**Sayam Knit Fab  
Rose Tex Knitting  
Vaivai Printing  
Rahman Sports  
Paisley Printers**

A/88,BSCIC 1/A, Shasongaon, Enayetnagar, Fatullah, Narayangonj, Bangladesh  
( 23.62304N 90.47902E)

14 May 2014

# Observations - Building 2

## Column Strength

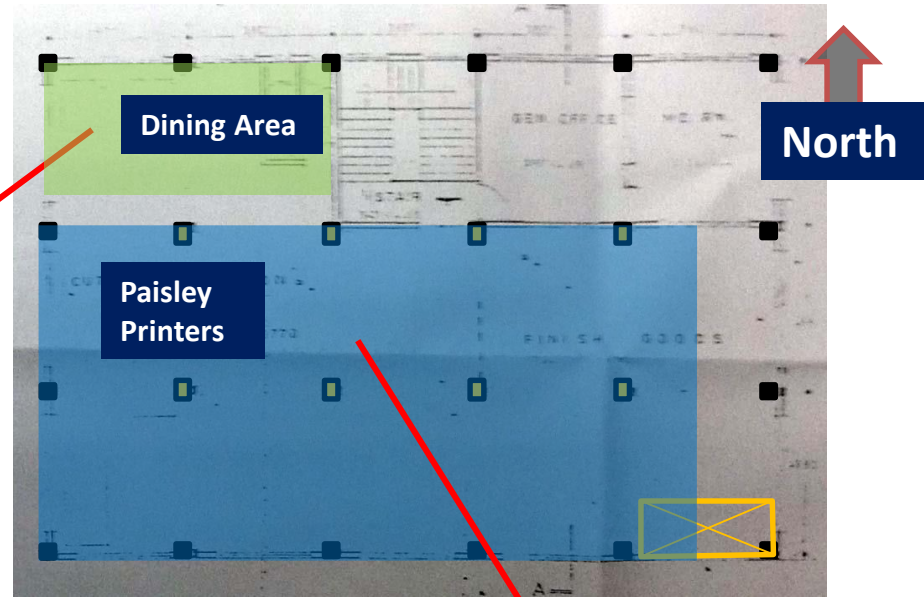
**Columns appear to be stressed to a  
high level and require immediate  
review**

Outline calculations indicate that columns are stressed to a high level and require immediate review.

Building Engineer to perform detailed calculations including a Detail Engineering Assessment (see attached scope) and concrete tests to prove adequacy of column sizes, and (if required):

- Reduce loads by vacating floors
- Reinforce columns

## Management of Floor Loads

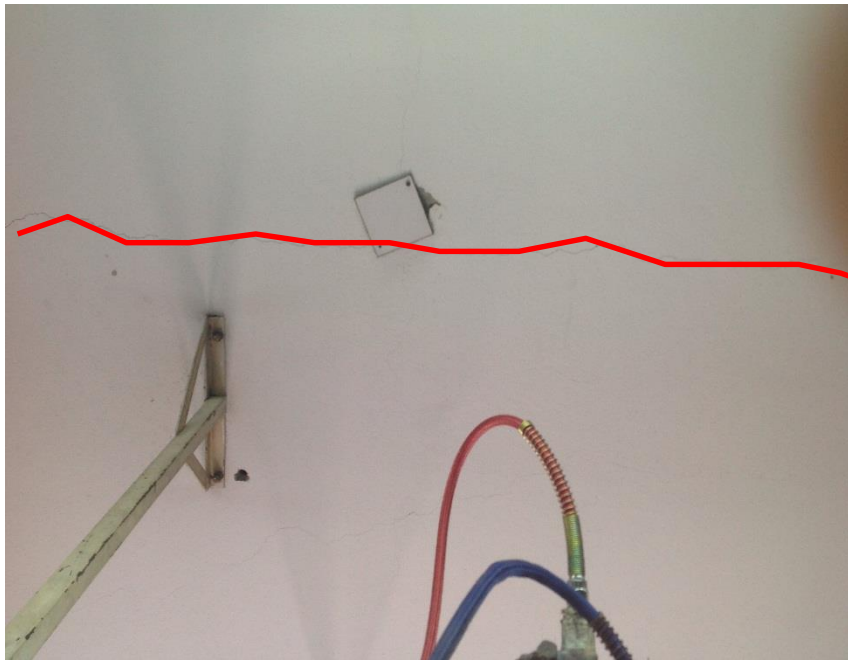
Floor loads at 4<sup>th</sup> Floor

Floor loads at 3<sup>rd</sup> floor

Building Engineer to prepare controlled loading plans, based on floor slab and column capacity, for all floors which will designate allowable storage density and where storage may be placed.

## Beam Crack on 4<sup>th</sup> Floor Soffit

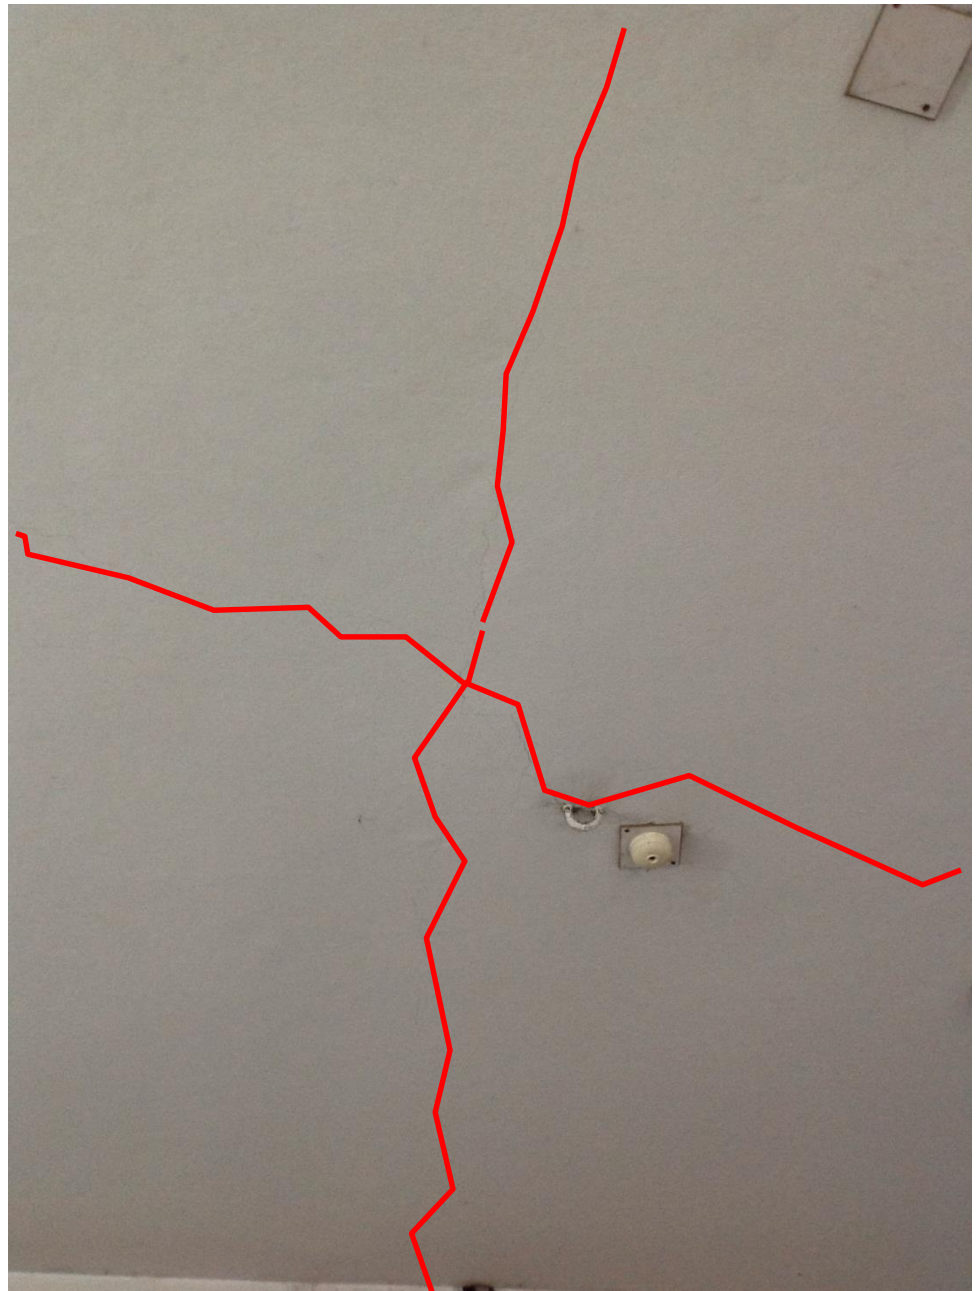
**Cracking of beam on the 4<sup>th</sup> floor soffit, cracking of roof slab soffit and apparent hanging brickwork on the 2<sup>nd</sup> floor soffit**

Crack on Beam

Cracking to beam on 4th floor to be reviewed by removing plaster to assess whether crack extends into structure.

## Cracking of Roof Slab Soffit

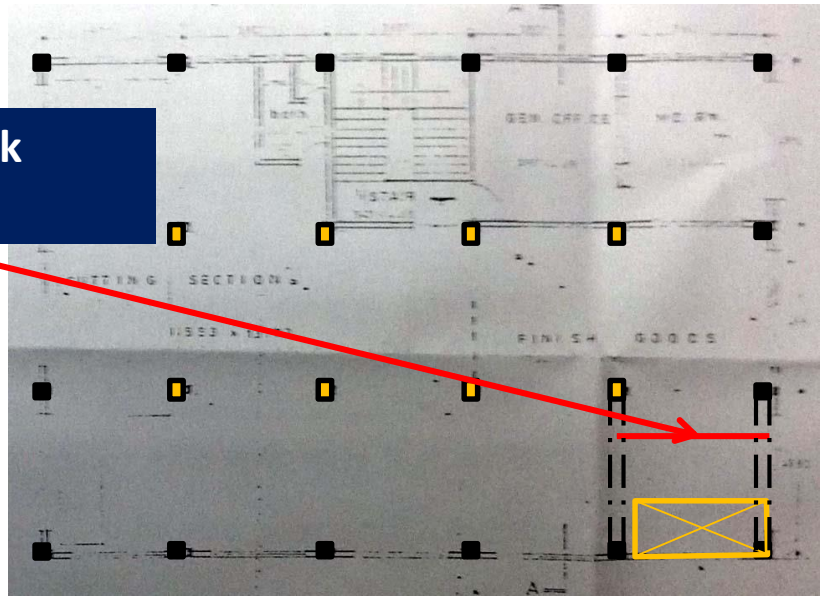
Signs of cracking in a number of locations on the roof slab soffit.

Cracking in soffit of flat slab to be reviewed by removing plaster to assess whether cracks extend into structure. Building Engineer to confirm flat slab imposed design load capacity.

**Apparent hanging Brickwork on 2<sup>nd</sup> Floor Soffit**

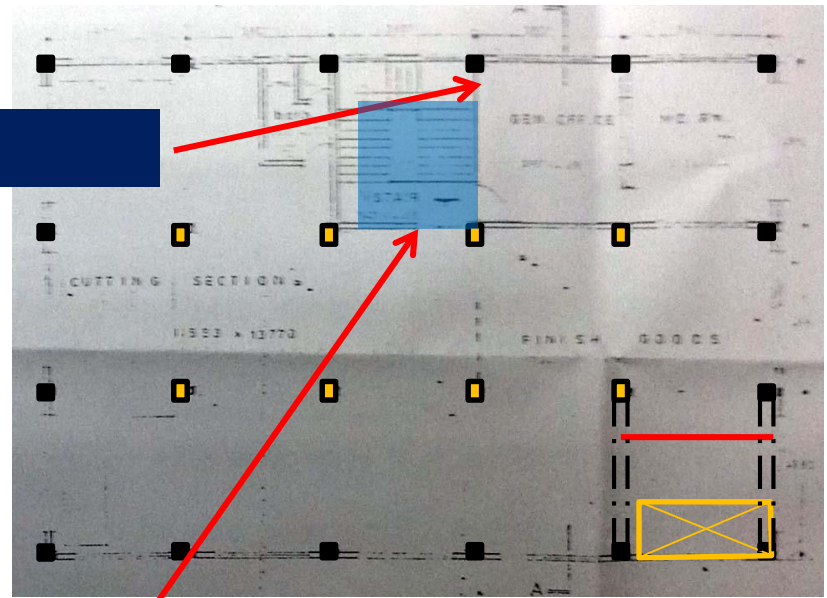
**Apparent brick work without lintel**

**Evidence of a demolished wall remain hanging from the slab soffit. Building Engineer to review if this is of concrete or brick construction. If constructed of brickwork these works should be removed.**

## **Water Tank Support**

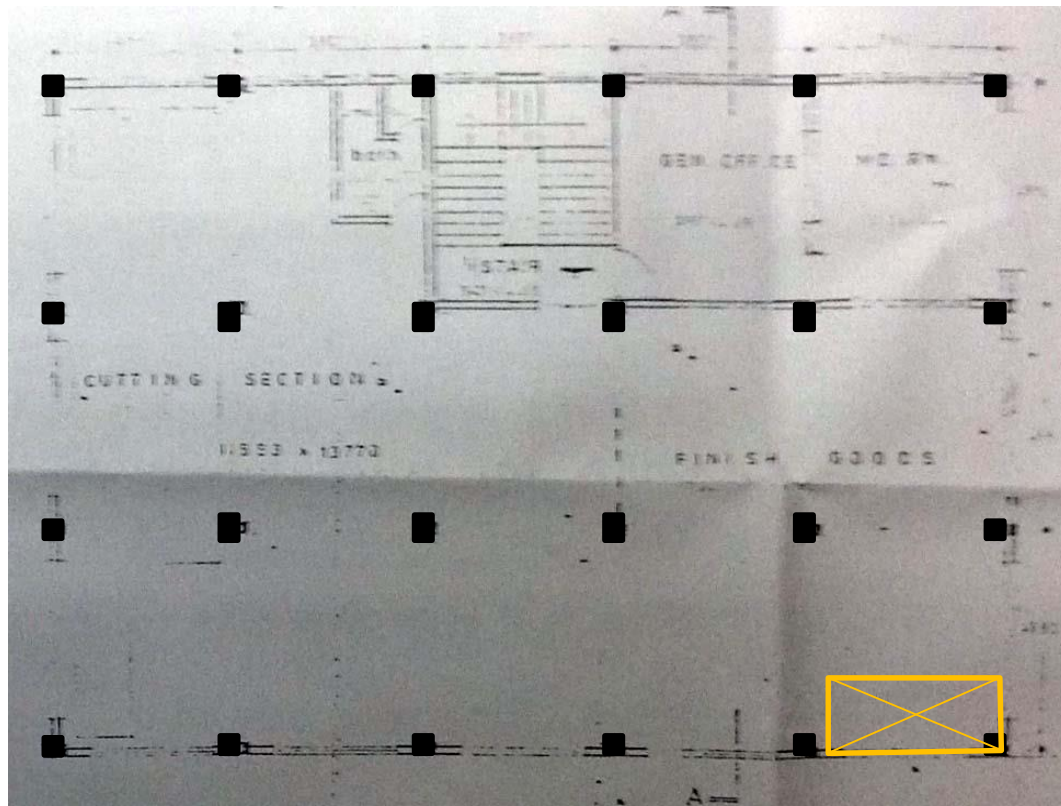
**Crack to brick wall**

**Concrete Water Tank may be supported on brick work on one side resulting in cracking – Building Engineer to review and confirm adequacy of water tank support structure.**

### Missing structural drawings and discrepancies

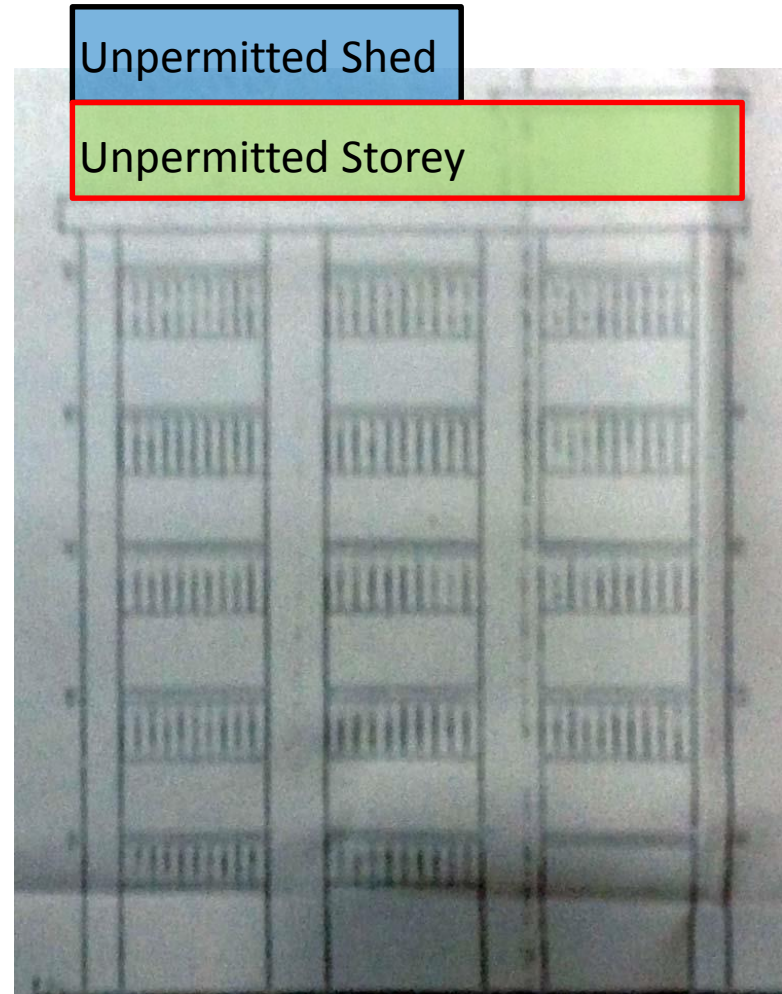
Permit structural drawings were provided. These do not show details of roof flat slab construction. Building Engineer to update drawings with as-constructed survey.

Permit drawing shows 5 storeys, but 6 storeys plus sheds at roof level are constructed.

## Column Strength

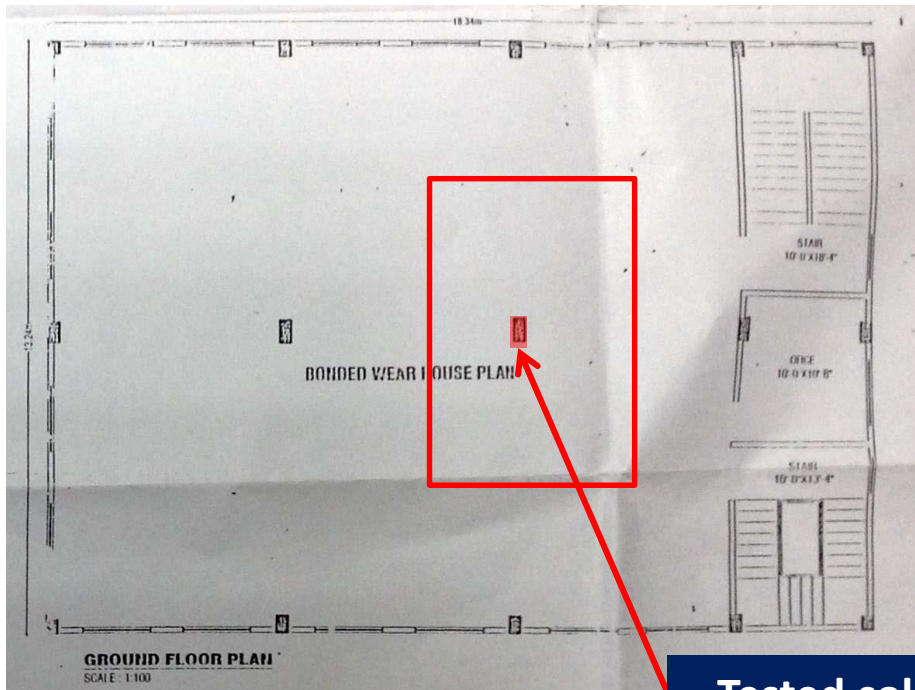
**Columns appear to be stressed in  
excess of normal design limits**

Outline calculations indicate that columns are stressed in excess of normal design limits.

Building Engineer to perform detailed calculations and concrete tests to prove adequacy of column sizes, and (if required):

- Reduce loads by vacating floors
- Reinforce columns

## Management of Floor & Water Tank Loads

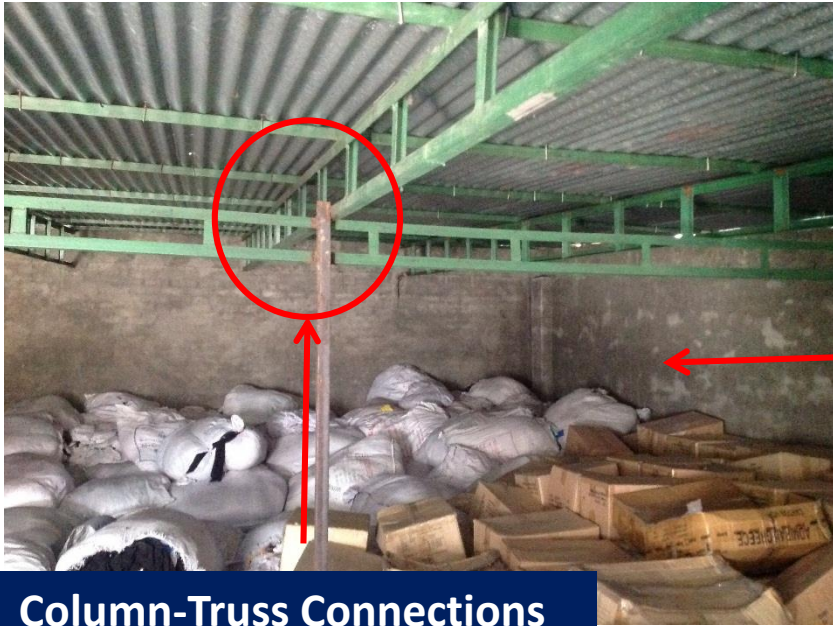
2 x 2,000 litre plastic water tanks at roof level

Loads on 2<sup>nd</sup> floor

Building Engineer to prepare controlled loading plans, based on floor slab (including punching shear) and column capacity, for all floors which will designate allowable storage density and where storage may be placed.

## **Steel Roof Structures**

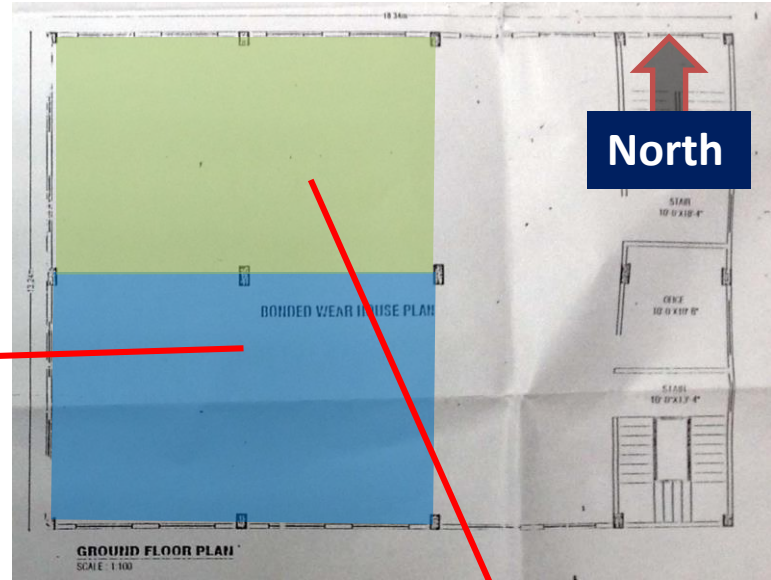
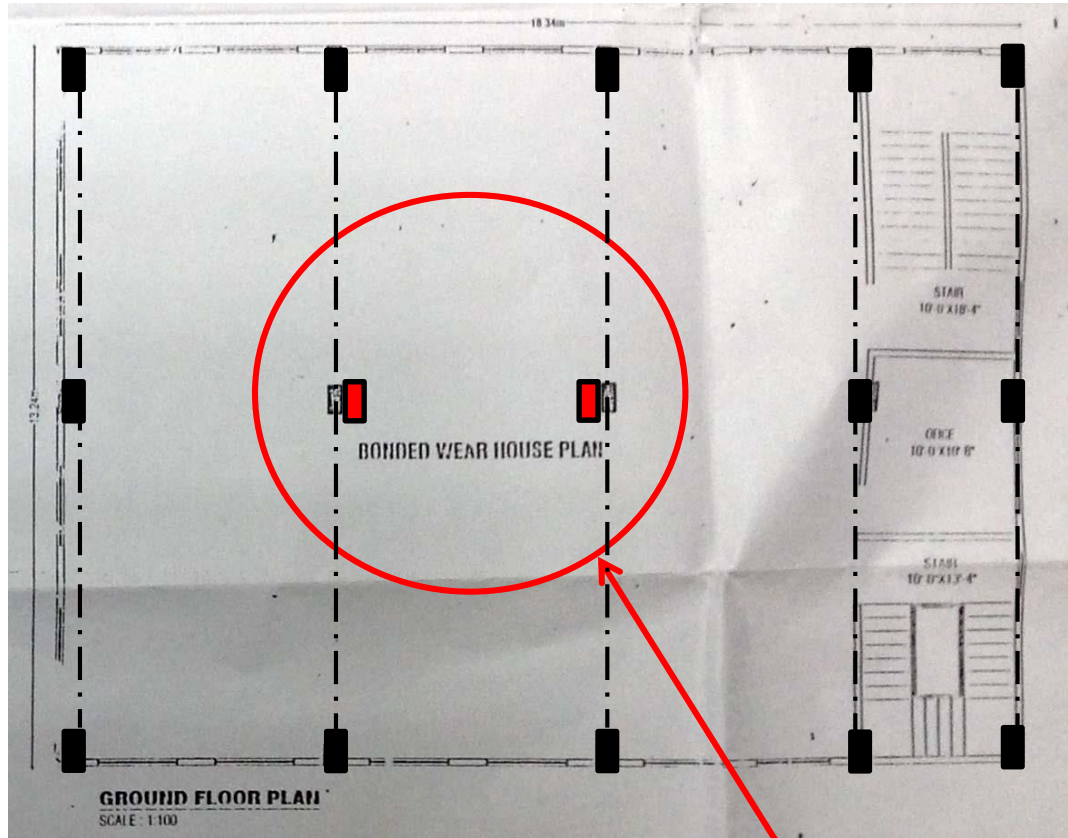
**Column-Truss Connections to be reviewed**

**Anchorage of Roof Trusses to be reviewed**

**Building Engineer to check adequacy of the steel roof structure and connections for code specified live load and wind loads**
